PLAN COMMISSION MEETING AGENDA

**TUESDAY, August 23, 2016
AT 6:00 PM**

Plan Commission Report

PROJECT: Plan Review – Rick Ruvin, RW Howell, LLC (Children’s Hospital Addition)

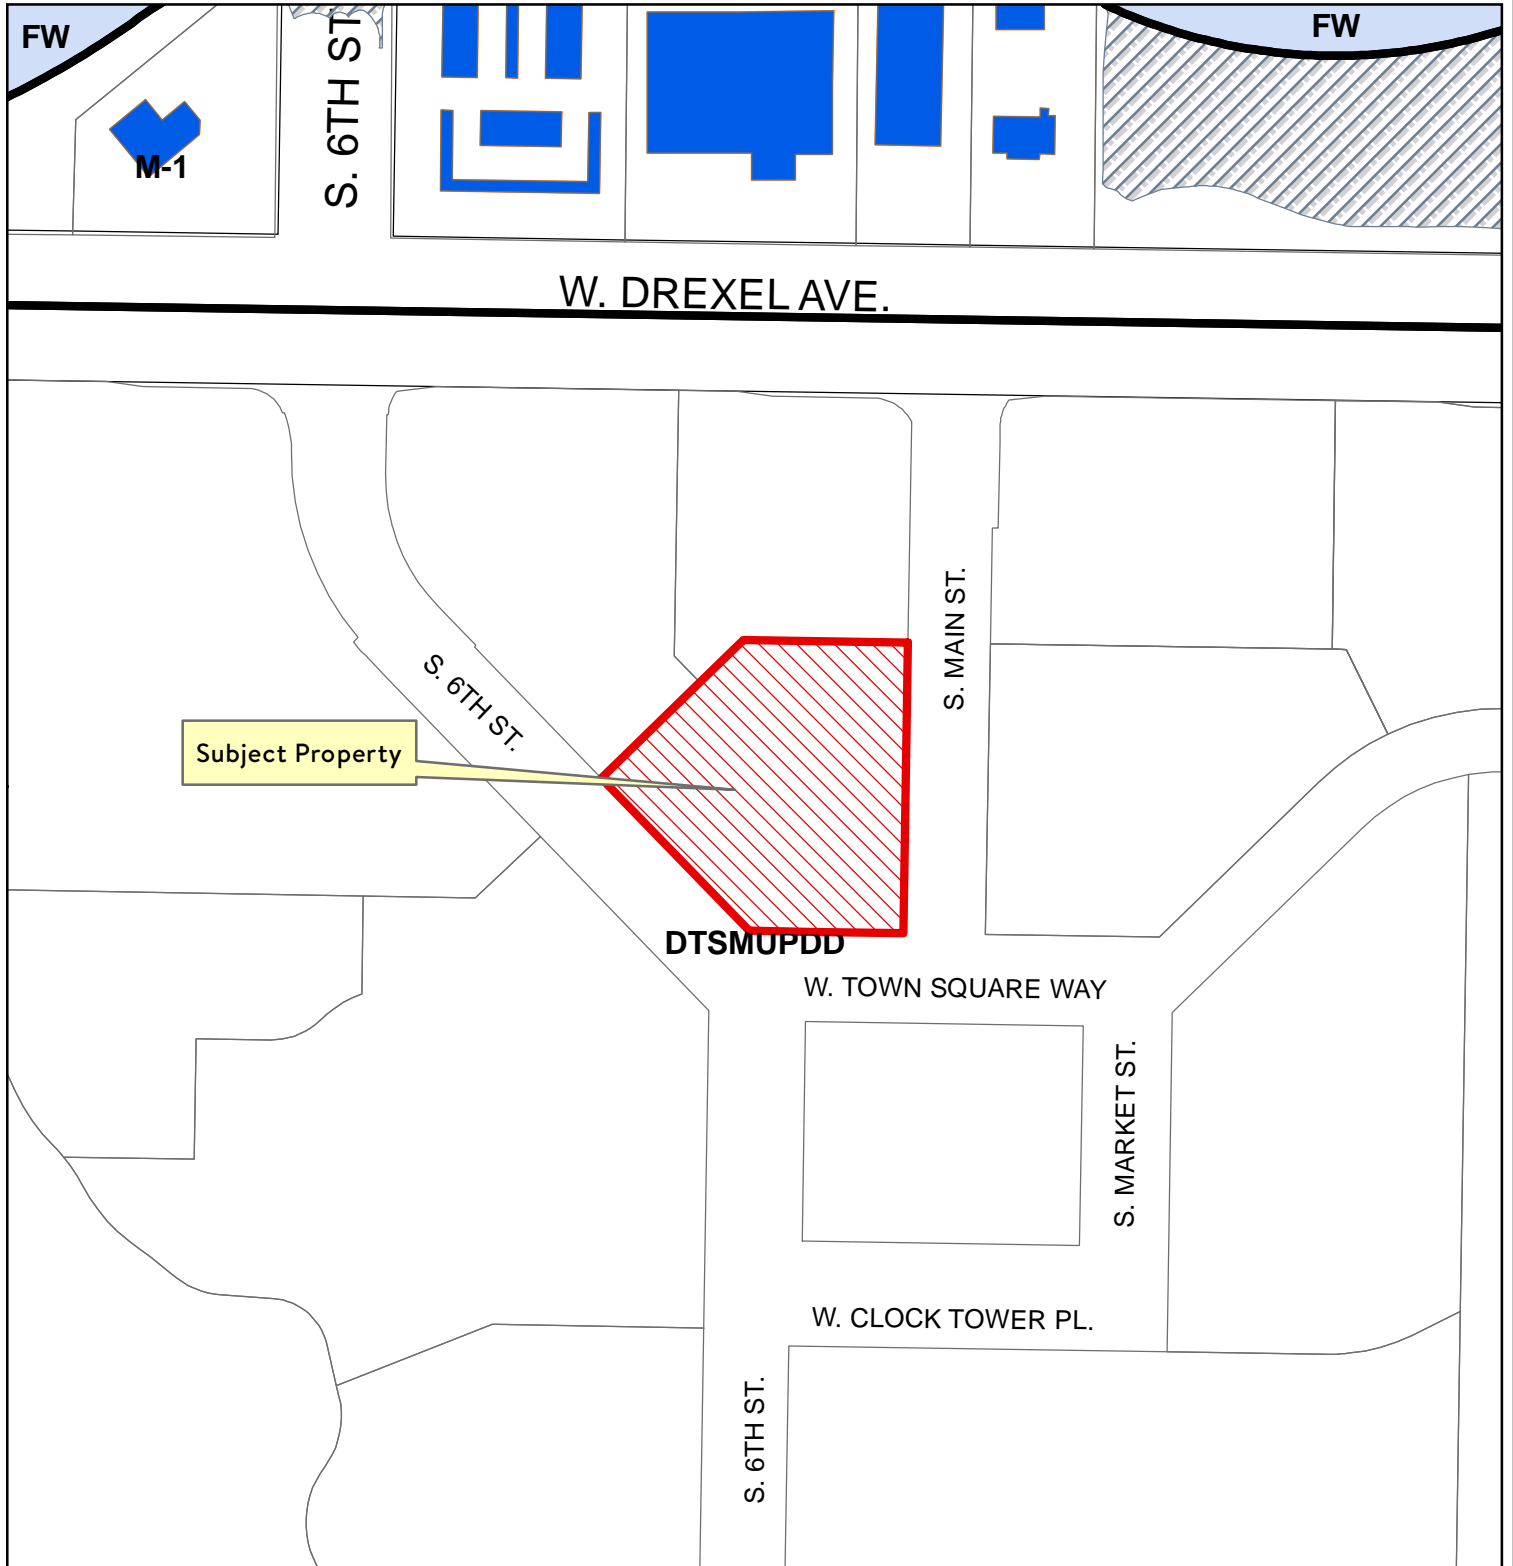
The blue Martinizing letters are the traditional channel letter design mounted to a raceway (that will match the building facade) that is attached to the wall. The “green cleaning” sign will be a push-through channel letter design. Push-through means that the letters will be raised from the green base as illustrated in your report. The green base will not be illuminated, however, the white letters will be illuminated. This design provides the applicant the ability to display their brand, but not construct an internally lit cabinet, which is prohibited in this zoning district.

STAFF RECOMMENDATION: That the Plan Commission approve the sign plan for Martinizing located at 7979 S. Main Street.

2 North Elevation

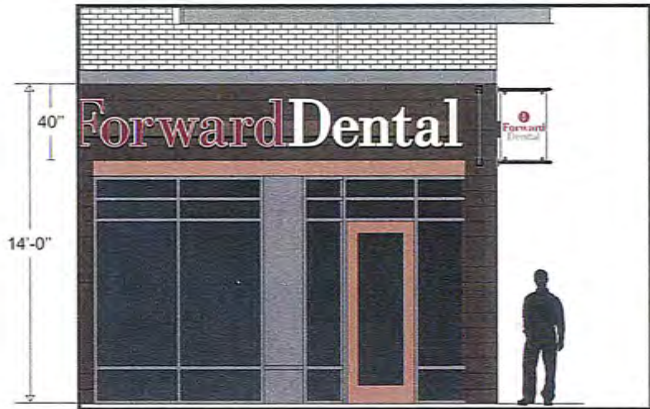
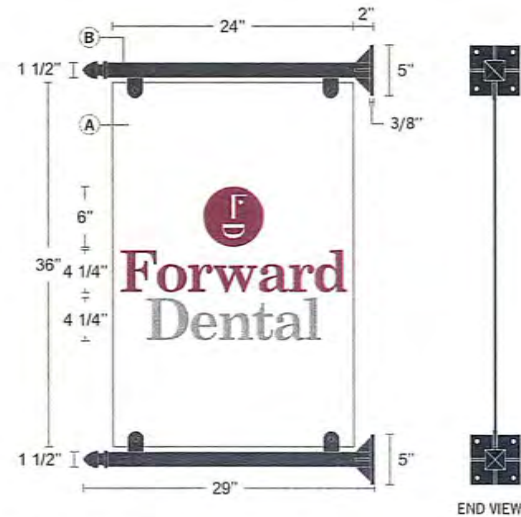
Commentary: The applicant is proposing to install a total of four signs. One wall sign would be installed on the east elevation (entry façade) and another wall sign on the north elevation (non-entry façade). Similarly, the applicant is proposing to install two blade signs, one the east (entry façade) elevation and one on the north (non-entry) elevation. According to the DTSMUPDD development plan, a tenant is allowed one wall sign per entry façade and 1-2 blade signs per entry façade.

The proposed wall signs will be of channel letter design, mounted to a raceway which will be attached to the building. The raceway will match the color of the façade. The “Forward” letters and logo will be colored burgundy and the “Dental” letters will be colored white. The signs will be illuminated with LEDs. Both wall signs are 25 inches in height and are 42.2 square feet in area. These dimensions are compliant with the DTSMUPDD development plan; however, the proposed landlord sign program limits the overall square footage of wall signs to 35 square feet. The overall square footage will need to be revised to comply with the requirements of the sign program.

Both the wall signs and blade signs meet the sign design standards for this district, however, the number of signs exceed what is permitted in this zoning district. If the applicant wishes to install all four signs, the applicant will need to apply for a sign appeal.

STAFF RECOMMENDATION: That the Plan Commission approve the wall sign and flag sign on the entry façade (east elevation) for Forward Dental located at 7955 S. Main Street.

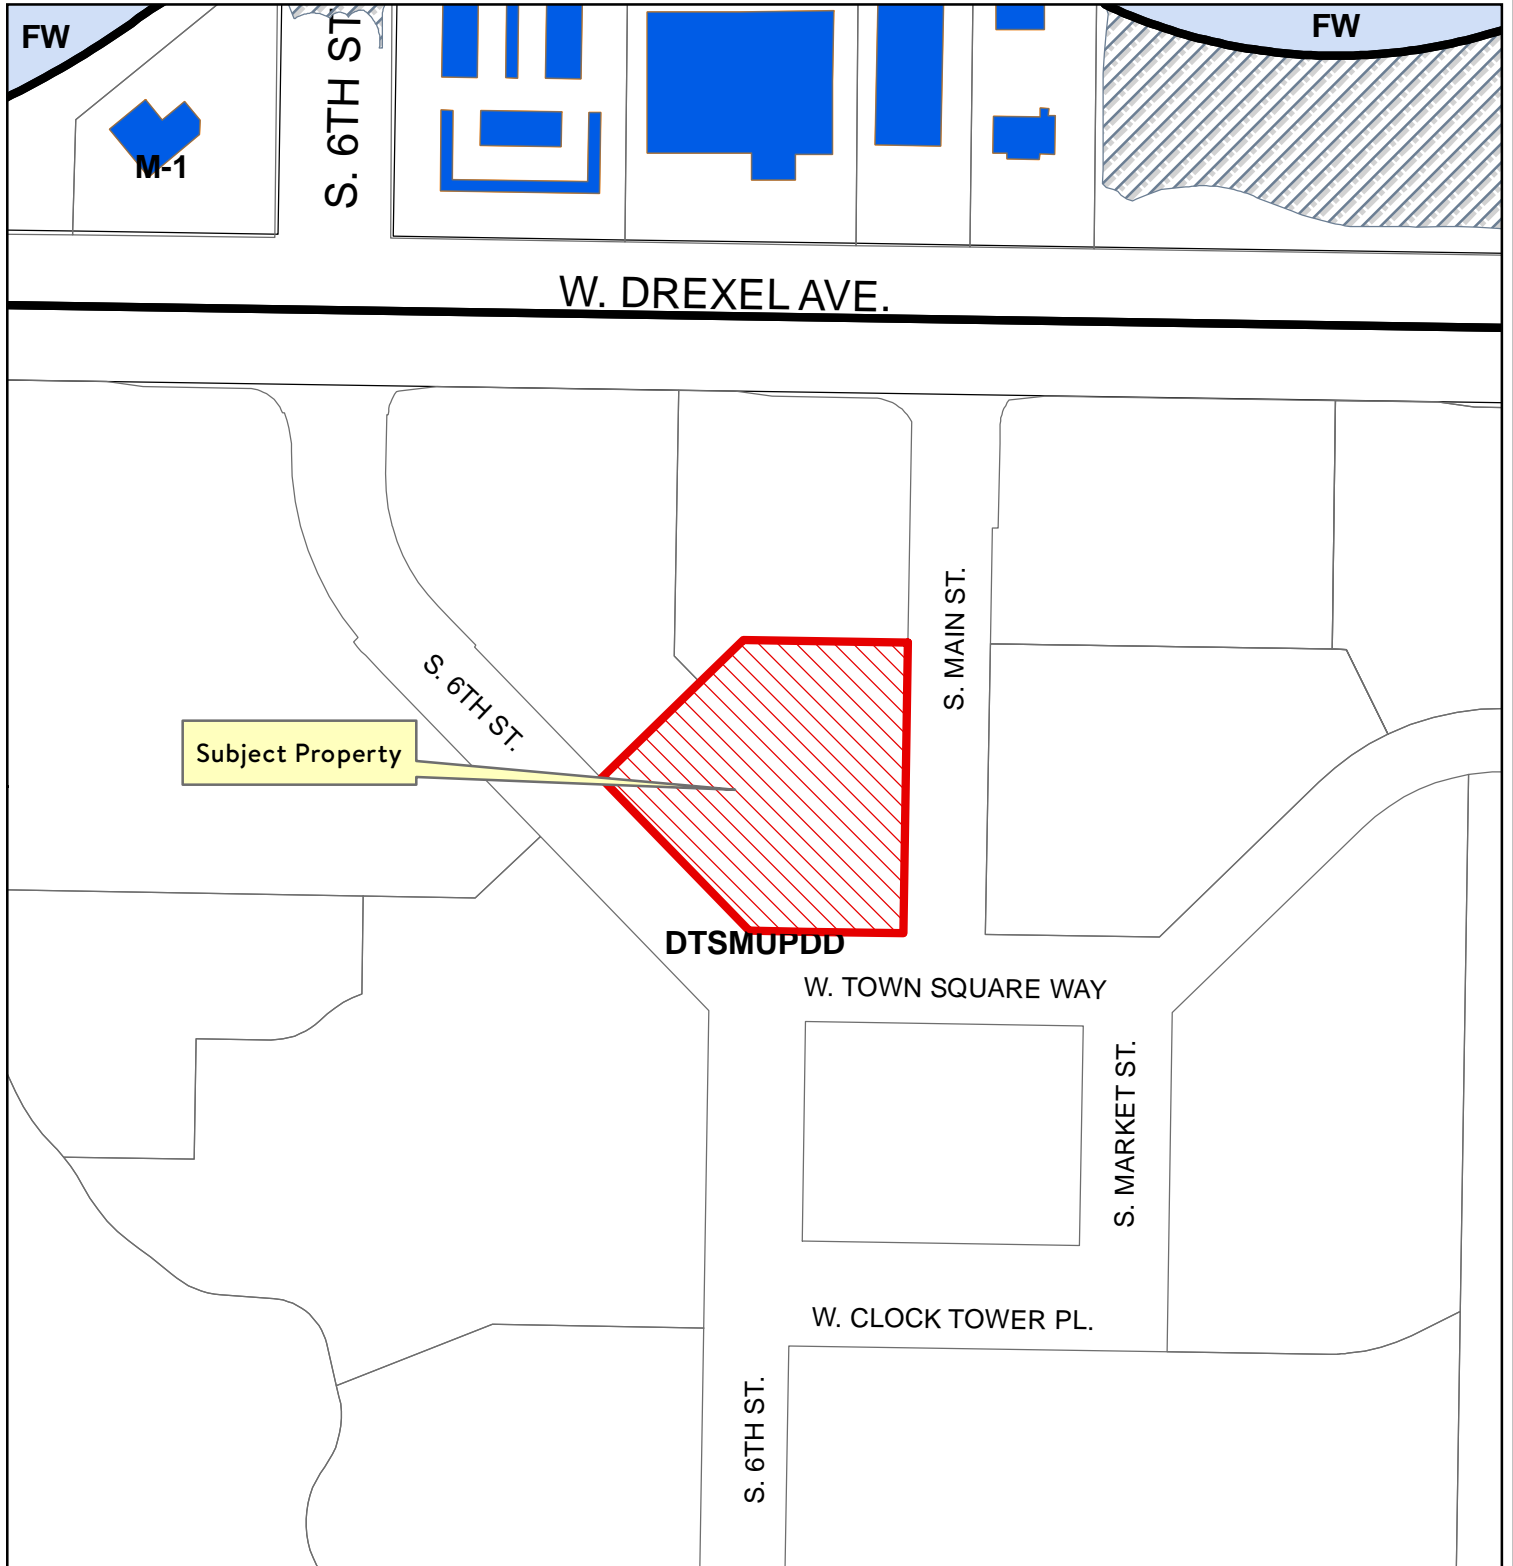
Commentary: The applicant is proposing to install one wall sign over the entry facade. The proposed sign will have a wall height of 30 inches, which exceeds the 25.2 inch maximum based on the DTSMUPDD Development plan that states signs shall not exceed 15 percent of the first floor wall height.

The exterior of the building shows material changes at approximately 14 feet. This would visually lead one to conclude that the first floor terminates at the material change, which would limit the height of the signs to 25.2 inches; however, the proposal shows a height of 30 inches for the sign. Staff feels that the overall sign height would be most appropriate and proportional at the 25-inch maximum, and is recommending such in the conditions of approval above. Other tenants in this building have met the 25-inch height limit.

Based on the DTSMUPDD Development plan, the proposed sign does not meet sign regulations. There is a master sign program being proposed for this development that would allow up to a 32-inch sign. However, as of the writing of this report, the sign height limit is 25.2 inches. The Commission has the discretion to approve a master sign program allowing for a larger (height) sign. In such a case, the proposed sign would meet the criteria and would be recommended for approval.

STAFF RECOMMENDATION: That the Plan Commission **not** approve the sign plan for Roots located at 7959 S. Main Street.
